## ***Interactive comment on “The possible negative consequences of underground dam and reservoir construction and operation in coastal karst areas: an example of the HEPP Ombla near Dubrovnik (Croatia)” by T. Roje-Bonacci and O. Bonacci***

Received and published: 24 May 2013

Fig. 1. New Figure 3

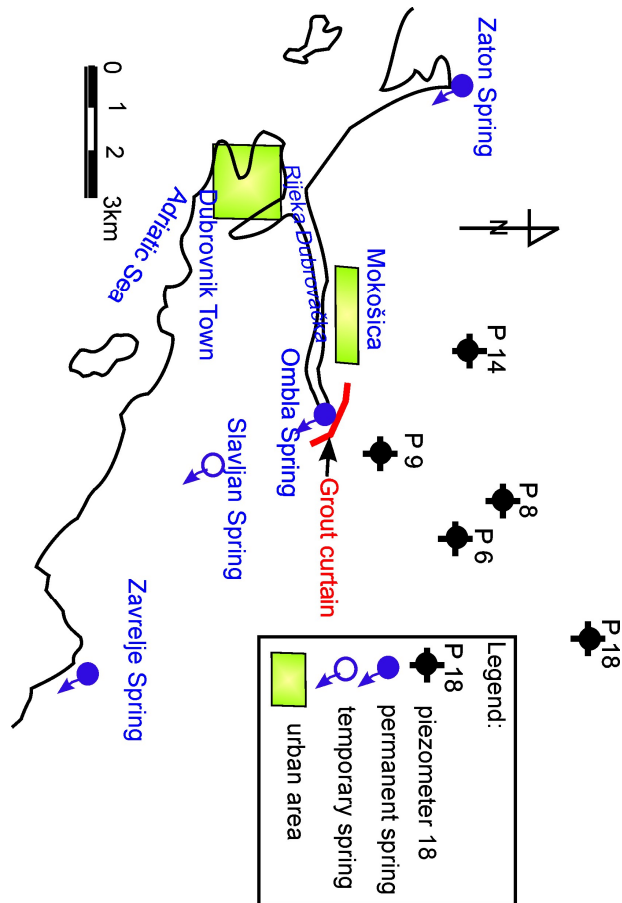
19) Fig. 3: piezometers in figure are five and not four; green boxes are not explained in

the caption. In Figure captions four is corrected by five, New Figure 3 with green boxes explanation is prepared.
